Re: Austin Community Recycling and Disposal Facility - Permit No. MSW 249-C
Class I Permit Modification Request
Final Landfill Contours and Drainage System Modification

On behalf of Waste Management of Texas, Inc., Rust Environment and Infrastructure is pleased to submit the enclosed documents as a modification of the Site Development Plan for the Austin Community Recycling and Disposal Facility (MSW 249-C). This permit modification request includes drawings showing revised final contours and drainage systems for the entire permitted facility and a drainage report providing erosion control and drainage design calculations.

PART A
AND
SITE DEVELOPMENT PLAN
FOR THE
AUSTIN COMMUNITY LANDFILL EXPANSION
PERMIT AMENDMENT APPLICATION 249-C
TRAVIS COUNTY
VOLUME I
MAIN TEXT THROUGH ATTACHMENT 15

PROJECT NO. 401 001 DATE 7/2/86 DRAWN BY JMD CHECKED BY JMD DATE 7/2/86	EAST LANDFILL DRAINAGE PLAN PREPARED FOR WMG PROJECT NO. 401 001
	Waste Management of Texas, Inc. 8-1B

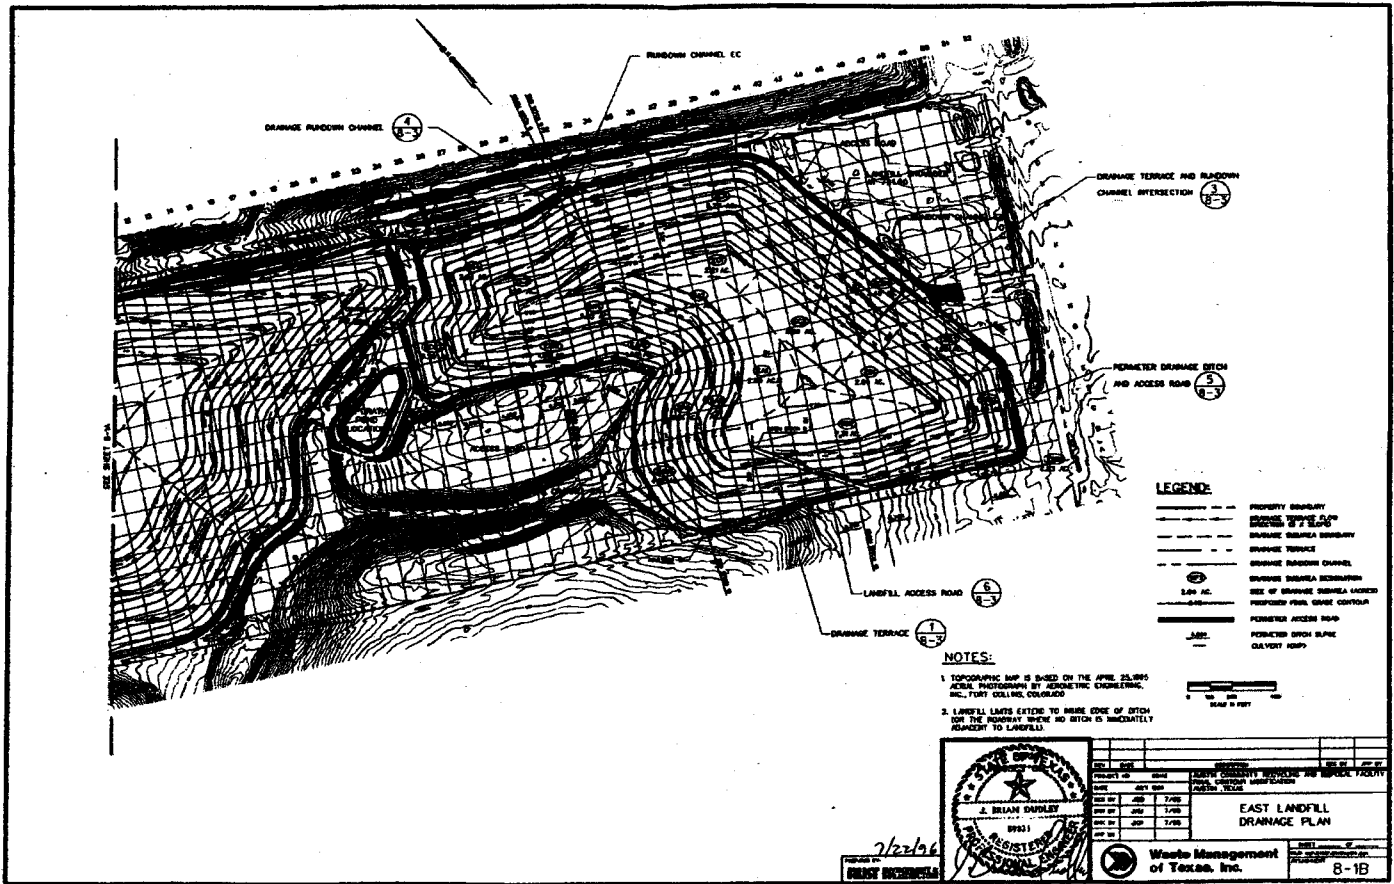
Replace Attachment 8-1 with new Attachments 8-1A and 8-1B. *These new drawings reflect the revised final contours and drainage configuration.*

THIS ATTACHMENT HAS BEEN SUPERCEDED BY THE JULY, 1996 PERMIT MODIFICATION. REFER TO ATTACHMENTS 9-1 AND 9-2 FOR THE LATEST VERSION.

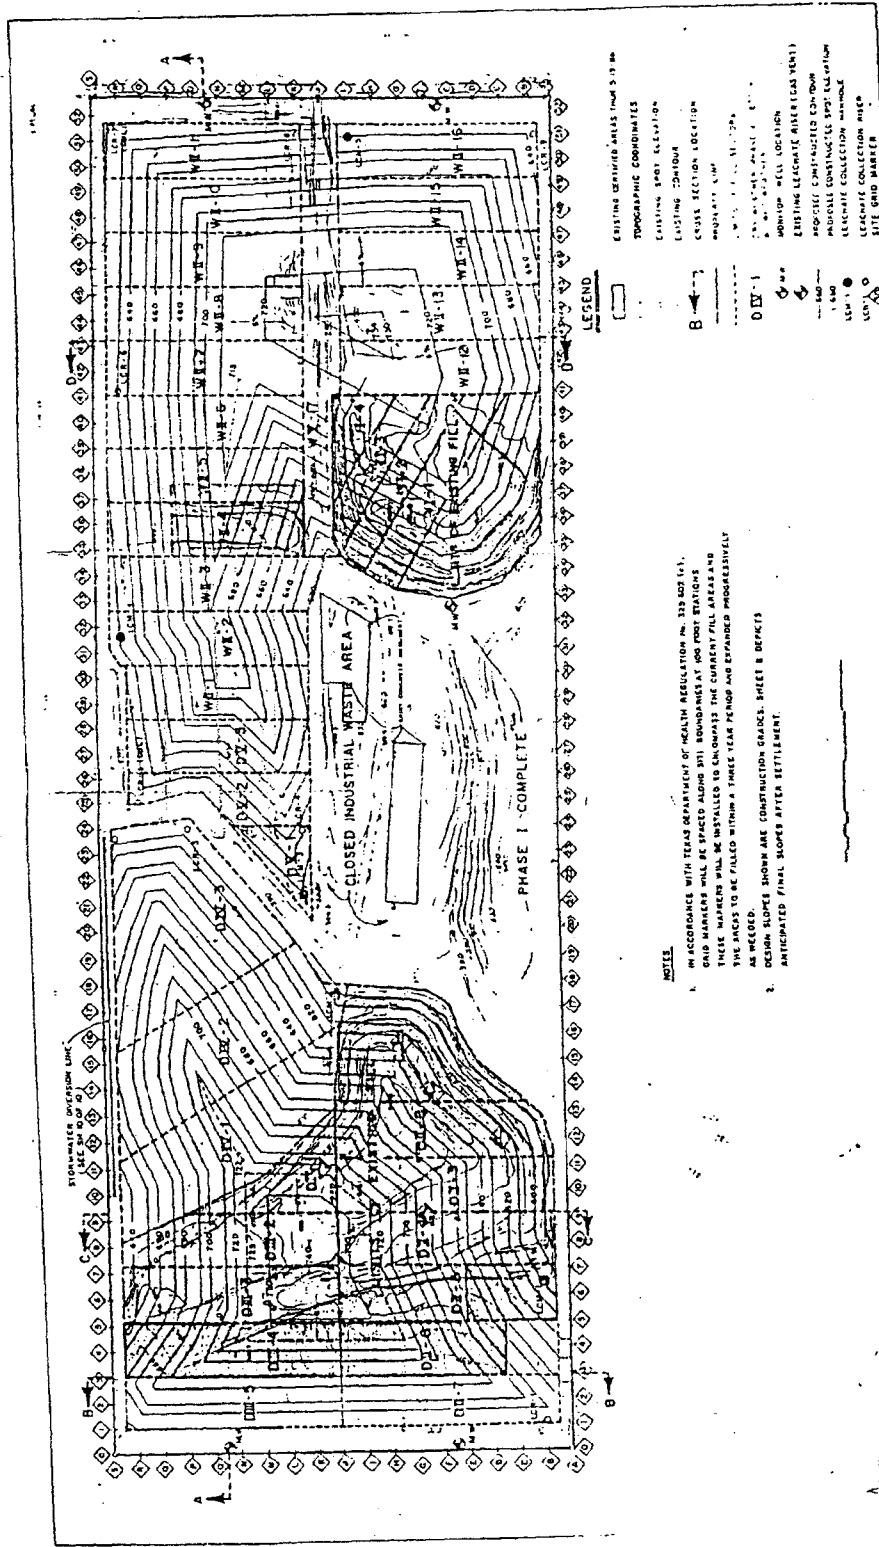
Replace Attachment 9 with Attachments 9-1 and 9-2. These drawings reflect the redesigned final contour plan.

THIS ATTACHMENT HAS BEEN SUPERCEDED
BY THE JULY, 1996 PERMIT MODIFICATION.
REFER TO ATTACHMENTS 7-1 AND 7-2 FOR
THE LATEST VERSION

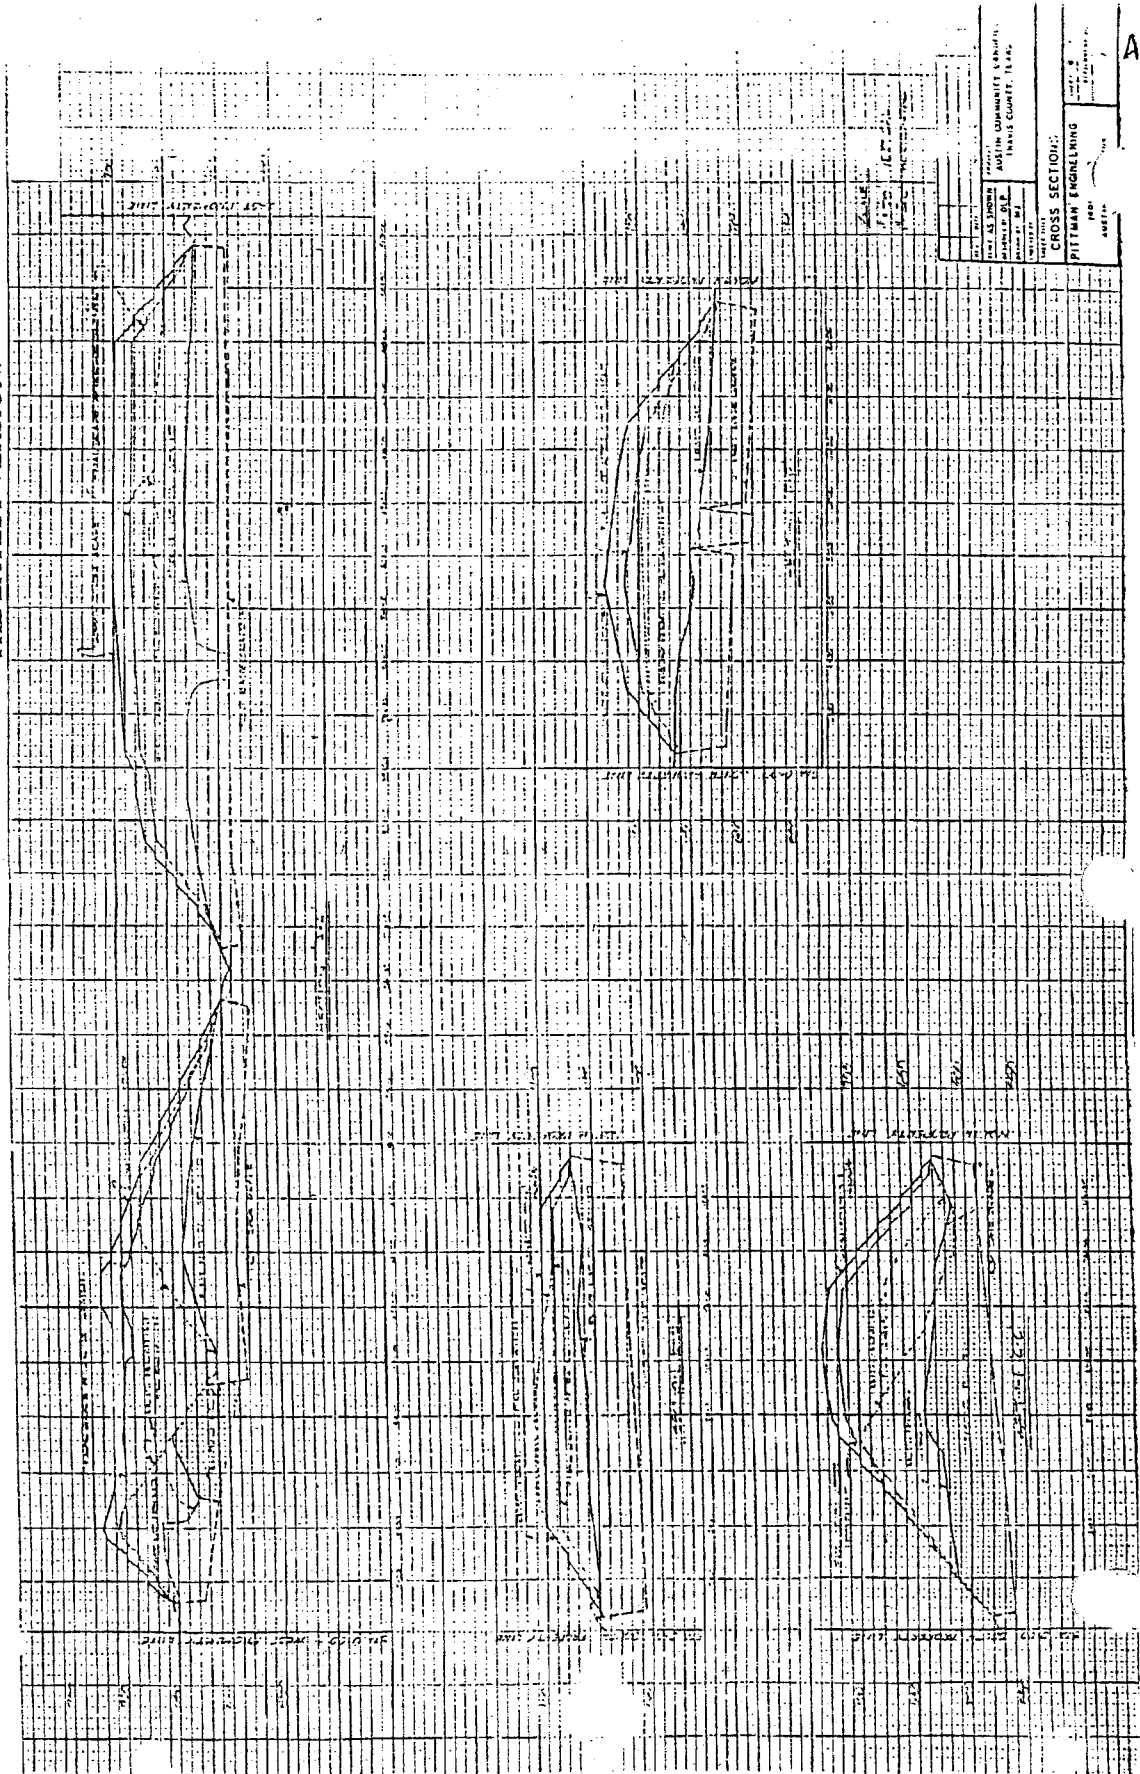
Attachments - Replace Attachments 7-1 and 7-2 with revised 7-1 and 7-2. *These new drawings revise the cross sections to show the revised grades included in the permit modification request.*
